Inspection Report
Minerals Regulatory Program
August 13, 2008

Mine Name: Eagle Canyon
Operator Name: Georgia Pacific

Permit number: M0150050
Inspection Date: July 1 and July 29, 2008
Times: 11:30 AM to 1:00 PM on July 1; 10:30-11:40 AM on July 29

Photo 1. Just to the left of center in this photo is a gypsum stockpile that has now been mostly buried.

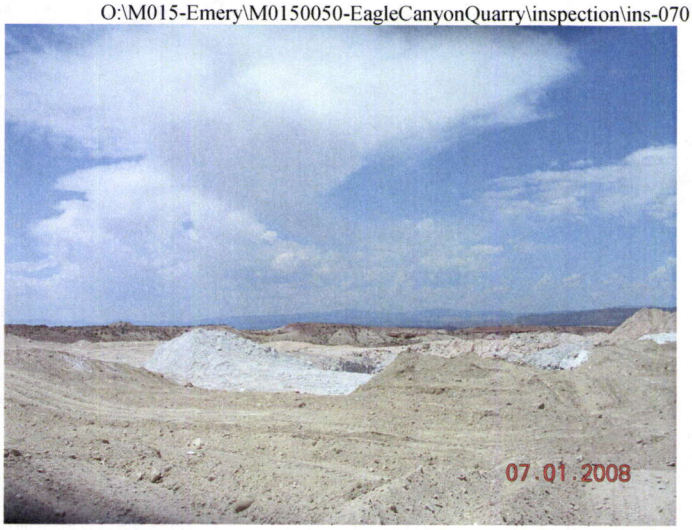
To the left of center in Photo 1 is a gypsum stockpile which by the inspection on July 29 had been almost completely buried. Other areas that were basically regraded are shown in Photos 2 and 3.
